Access Compliance Report

Public Rights-of-Way

Intersection ID: 22200	Main Street: S_TRYON_ST	Cross Street: JOHN_PRICE_RD	Location: SE
ADA ID: 0AD99C5EBD00	Ramp Type: PerpDiag	Initial Pass/Fail: Fail	Overall Compliance: No
Codes/Mitigation Info/Possible Solution		Field Measurements/Component Compliance	
Severity Score: 21.25

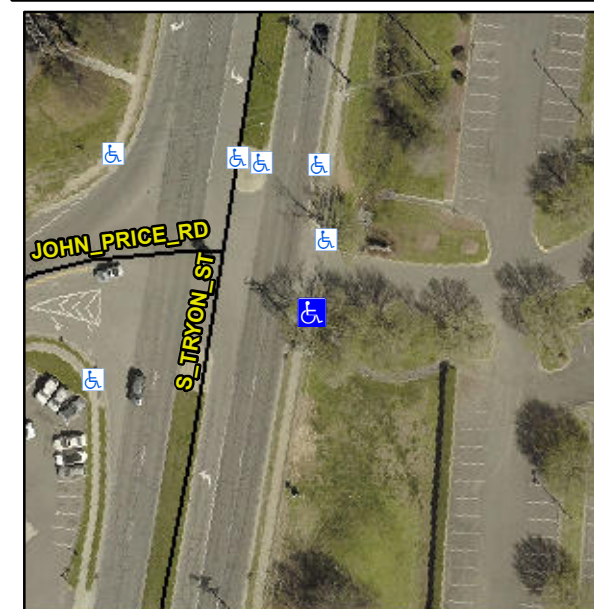
Not Found, R304.5.1, R304.2.2

Compliance	Description	Data	Compliance	Description	Data
N/A	Ramp Length (in)	88.0	No	Ramp Slope (%)	8.8
No	Ramp Width (in)	38.0	Yes	Ramp XSlope (%)	1.2
N/A	Flare Type LT	N/A	N/A	Flare Type RT	N/A
N/A	Flare Slope LT (%)	N/A	N/A	Flare Slope RT (%)	N/A
N/A	Flare Traversable LT?	N/A	N/A	Flare Traversable RT?	N/A
N/A	Landing Length (in)	N/A	N/A	DWS Provided?	N/A
N/A	Landing Width (in)	N/A	N/A	DWS Contrast?	N/A
N/A	Landing Slope (%)	N/A	N/A	DWS Length (in)	N/A
N/A	Landing X Slope (%)	N/A	N/A	DWS Full Width?	N/A
N/A	Landing Curb? (Y/N)	N/A	N/A	DWS Offset (in)	N/A
N/A	Shared Landing?	N/A			
N/A	Gutter Ponding?	N/A	N/A	Gutter Slope (%)	N/A
N/A	Gutter Lip Ht (in)	N/A	N/A	Gutter X Slope (%)	N/A
N/A	Painted X Walk1?	No	N/A	Painted X Walk2?	No
	X Walk 1 Direction	To N		X Walk 2 Direction	To W
N/A	X Walk 1 Width (in)	N/A	N/A	X Walk 2 Width (in)	N/A
	X Walk 1 Slope (%)	0.4		X Walk 2 Slope (%)	4.6
	X Walk 1 X Slope (%)	3.6		X Walk 2 X Slope (%)	1.5

Remove & Replace Curb Ramp With Two New Directional Ramps or Equivalent.
